PRODUCT / PROCESS CHANGE NOTIFICATION

1.1 Company		STMicroelectronics International N.V
1.2 PCN No.		ADG/18/10736
1.3 Title of PCN		Package Outline Change on PowerFLATTM ribbon version Products
1.4 Product Category		Power MOSFET
1.5 Issue date		2018-02-20

Package Outline Change on PowerFLAT™ ribbon version Products

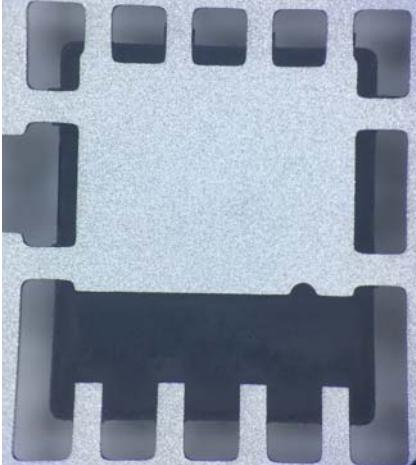
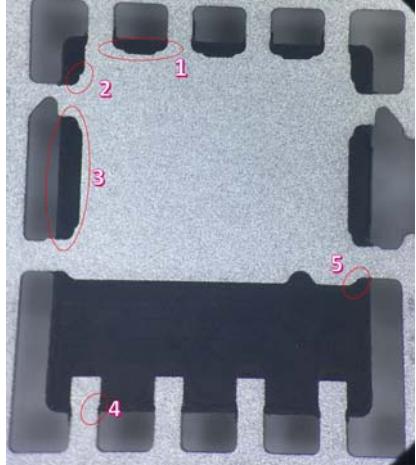
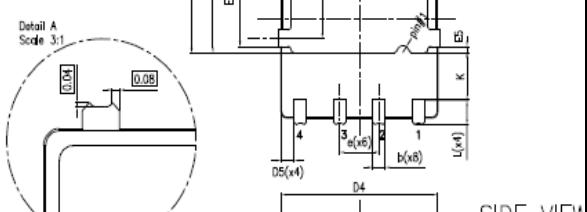
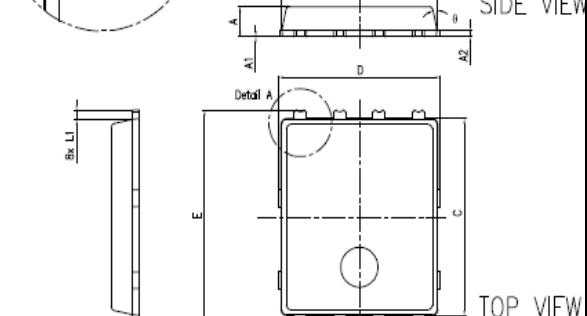
ST Part number:	Package: PowerFLAT™ Ribbon Version Back End plant: Shenzhen																																																																																																																																																								
Reason and background of the changes	To enlarge material availability introducing a new frame type to be used for all the ribbon version products in PowerFLAT™.																																																																																																																																																								
Impact on form, fit, function, or reliability.	No change in terms of electrical behavior and reliability performances. A small change in the package outline will be visible as reported in the comparison below:																																																																																																																																																								
Current Package – Etched Frame		Proposed Package – Stamped Frame

Datasheet	<ul style="list-style-type: none"> • No impact on all the electrical parameters. • Both the package outline are within current spec <div style="display: flex; justify-content: space-around;"> <div style="text-align: center;">  <p>BOTTOM VIEW</p> </div> <div style="text-align: center;">  <p>SIDE VIEW</p> </div> <div style="text-align: center;">  <p>TOP VIEW</p> </div> </div>
